**ON-SITE SEWAGE DISPOSAL SYSTEM  
HOWARD COUNTY HEALTH DEPARTMENT  
BUREAU OF ENVIRONMENTAL HEALTH**

ADDRESS: 12102 Frederick Road PROPERTY OWNER: Autumn Williams

TRENCHES:	Trench to be _____ feet wide. Inlet _____ feet below original grade. Bottom maximum depth _____ feet below original grade. Effective area begins at _____ feet below original grade. _____ feet of stone below distribution pipe.
LOCATION:	<i>In Back Yard, Directly Uphill of Swing Set</i>
PURPOSE:	Existing septic system has failed. Call for inspection when ground is opened so sanitarian can recommend repair.

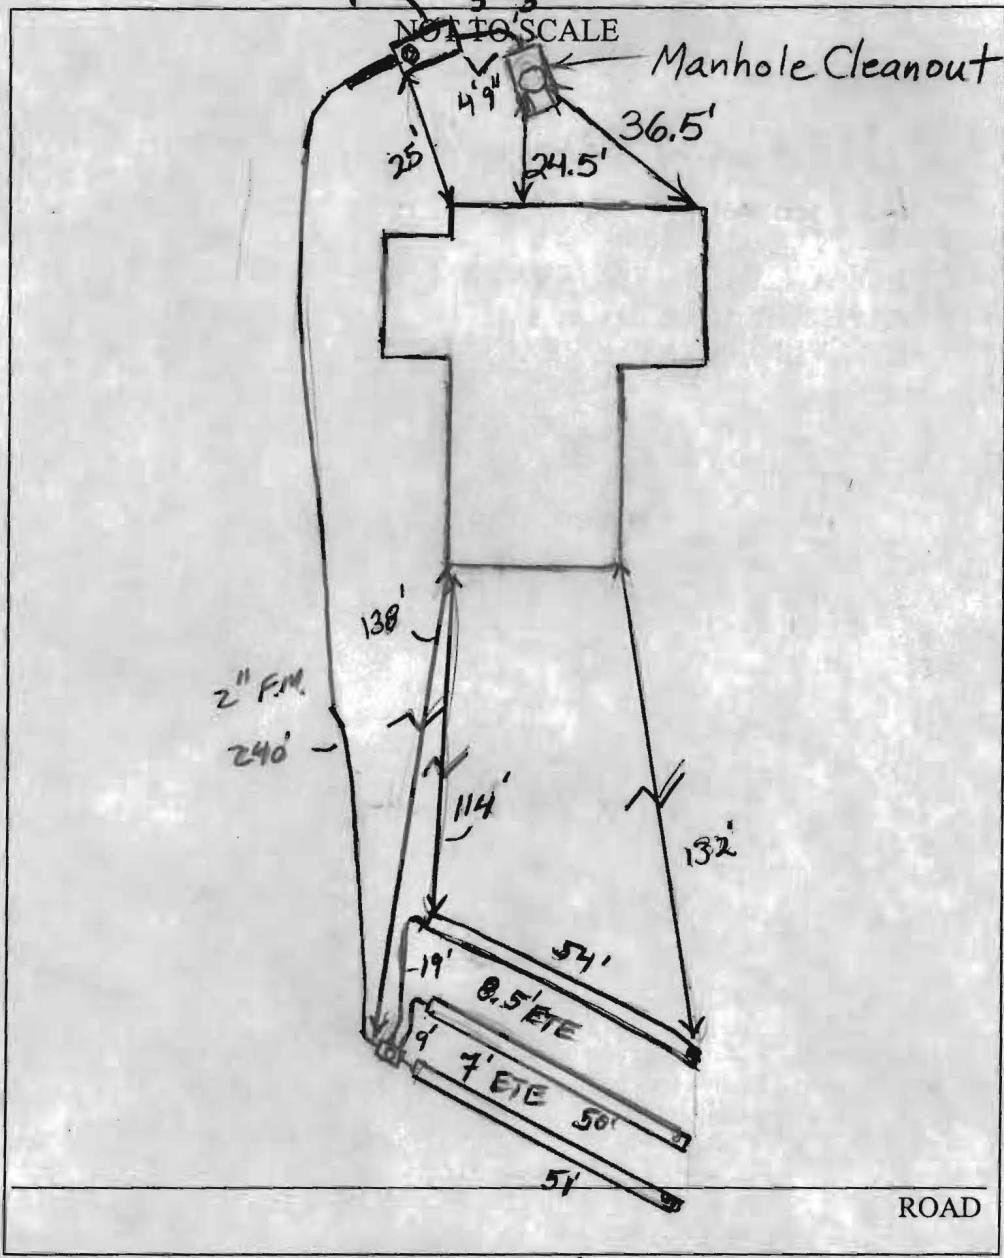
PRE-CONSTRUCTION 10/16/07 Trenches directly uphill of searing set. EZ Flow may be needed due to hill in back yard. (BB)

INSTALLATION 11/8/07 Contractor installed Highest absorption trench and 1/2 way dug middle trench w/ new spec's. (3.5'-8.5' Contractor dug second trench 7' ETE from Top trench. Told contractor keep 9' separation to edges on last trench. OK to continue (KW) 11/9/07 Pump tank set. Need Pump and alarm test. Final trench dug. complete (KW) 12/13/07 Pump and alarm working. (BB)
